The Commonwealth of Massachusetts Department of Public Safety One Ashburton Place, Room 1301

September 20, 2004

RE: Suspension of Permit to Operate Wisdom "Sizzler" Amusement Rides

Location of 5/8" locknut

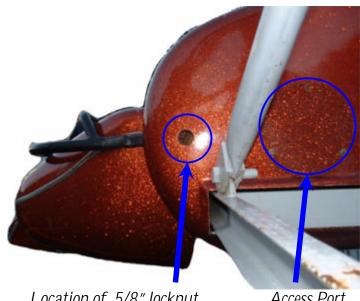
By design, each car side panel is secured with two (2) - 7/16 inch grade 5 bolts that screw into tapped holes at the base of the seat frame. Use of smaller sized bolts is prohibited unless engineered and approved by the ride manufacturer.

The lap restraints and foot tub are secured to the car side panels with two (2) 5/8" (requires use of a 15/16" socket), grade 5 bolts secured with lock nuts. These nuts shall be tightened as specified by the manufacturer. These nuts can be viewed and tightened from the side access panels on the car. Use of nuts that do not have locking capacity is prohibited.

Verification shall be performed by removing the fiberglass seat on each car. This will enable you to view the bolt closely to ensure proper sizing and grade as designed by the manufacturer.
